<b>Application Number</b>	20/00591/AS	
<b>Location</b>	Zone A, Waterbrook Park, Waterbrook Avenue, Sevington, Kent	
<b>Grid Reference</b>	00041504	
<b>Parish Council</b>	Sevington	
<b>Ward</b>	Mersham, Sevington South with Finberry	
<b>Application Description</b>	Application for the approval of reserved matters including, layout, scale, appearance, access and landscaping in relation to the erection of a new storage and distribution centre including ancillary offices, including associated access, parking, landscaping and associated works	
<b>Applicant</b>	GSE Commercial Estates Ltd, c/o Agent DHA Planning Ltd Eclipse House Eclipse Park, Sittingbourne Road, Maidstone ME14 3EN	
<b>Agent</b>	DHA Planning Ltd, Eclipse House, Eclipse Park, Sittingbourne Road, Maidstone ME14 3EN	
<b>Site Area</b>	7.5 hectares

## Proposal (Amended)

**Figure 3a:** fine detail of decked parking

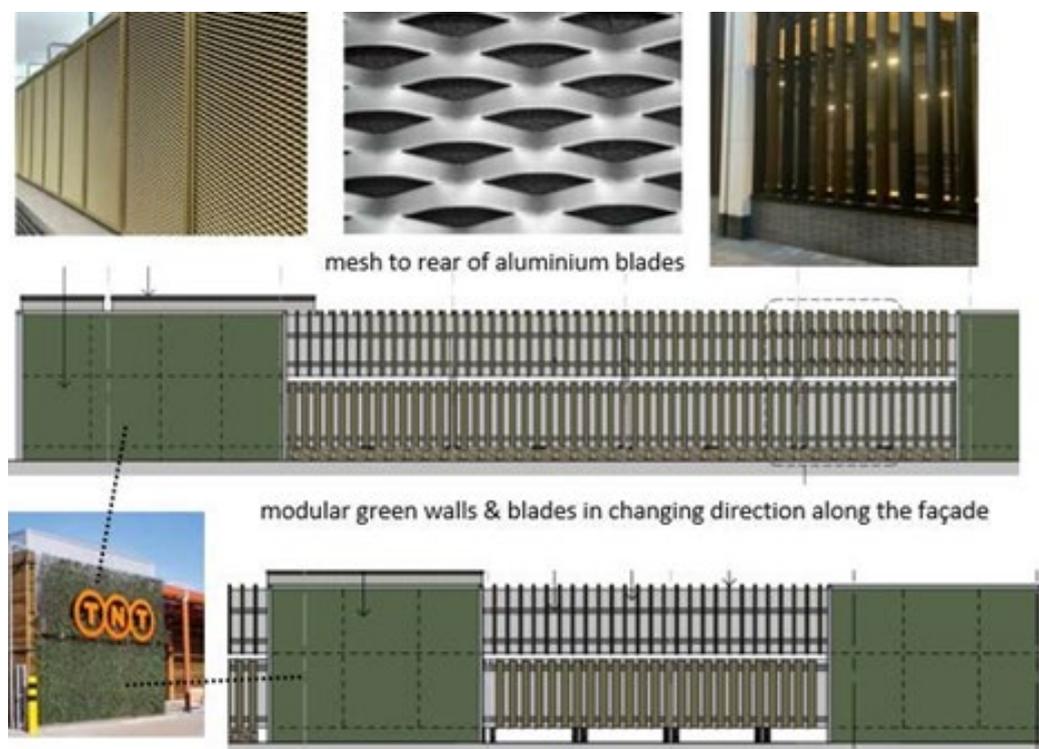
8. **Figure 3:** Elevations of new 2 storey van park structure The structure would measure approximately 68m x 145m and 8.2m high. The external façade (especially where this faces Waterbrook Avenue) would be treated with aluminium blades with a timber grain appearance installed at different angles alongside a series of green walls. Mesh would be provided to the inner face of the blades. The approach taken seeks to break up the massing of the structure on its longest side presented to the public realm and provide a visually softer aesthetic while also managing the need for ventilation. Figure 3a below shows the proposal in further detail.

9. The upper open deck would have 5 metre high LED columns lights that would protrude over the enclosed sides that would be 3.1m high above the deck (and thus designed to screen parked light vans (typically 2.7m in height) from non-elevated viewing positions around the site). The precise number of lights is to be confirmed by the applicant as it currently not shown.

**Figure 4:** Main building amended south and west elevations.

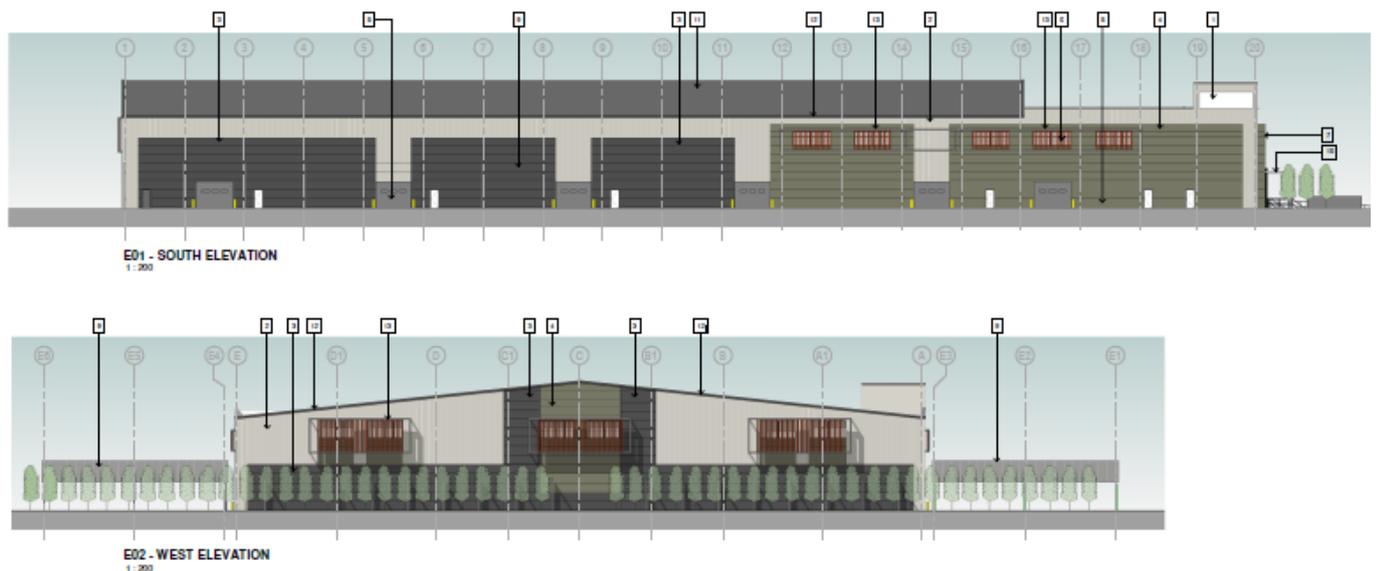
10. The main building has been moved further to the west to a more central location on the plot. The elevations have been reoriented with the lorry delivery docking area moved from the west to the east elevation. The general dimensions of the building remain similar as before 126m in length by 77m in width and 14.5, high to the pitched roof (10.5m to eaves level). The pitched roof however now covers only  $\frac{3}{4}$  of the building, the last  $\frac{1}{4}$  at the eastern end has a flat roof. There is a small tower at the south east corner that protrudes above the flat roof. The proposed elevations are shown in figure 4.
11. The external finishes have been amended. The elevations in the original scheme were finished mainly in a simple composite cladding in a white grey colour with a darker merlin grey central band. The amended scheme's external finishes are more varied

with the elevations finished in a combination of white grey, anthracite and olive green composite cladding, an aluminium curtain walling system and the use of brise-soleil over the majority of window openings. The roof would still have a pitched single ply membrane grey composite finish as before. The elevations of the amended main building and previous scheme for comparison are shown on figures 4 and 5 below and at A4 size as **Annexes E and F**.

34. Whilst the size and form of the main building remains fairly similar to the original proposals its design has been amended with the introduction of a greater vertical emphasis through more varied cladding, colours which are softer and fit with the use of green walls and design features such as brise-soleil features which in my view

would assist with articulation of the eastern façade and how it wraps around to the long elevations of the building as well as providing a feature able to be viewed above the decked parking on the western elevation to Waterbrook Avenue.

**Figure 5.** Previous elevations.

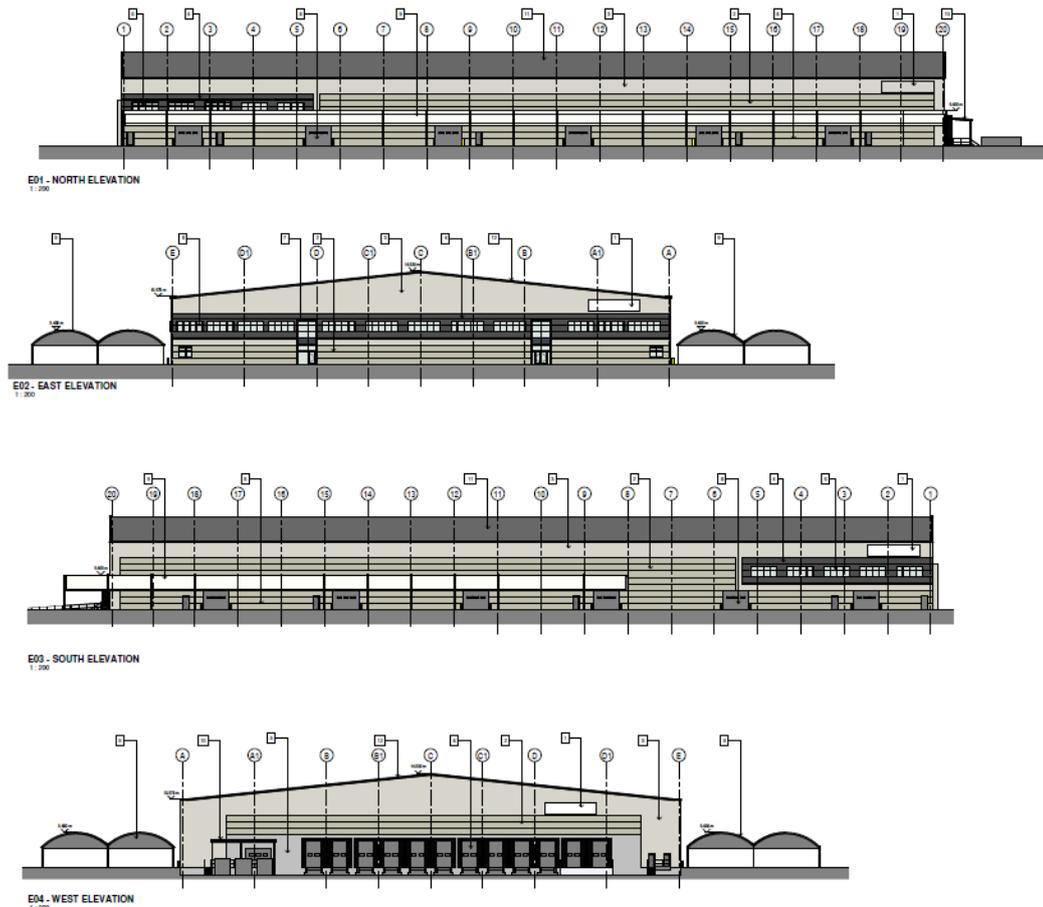
12. The previous elevations are shown below in figure 5 below.
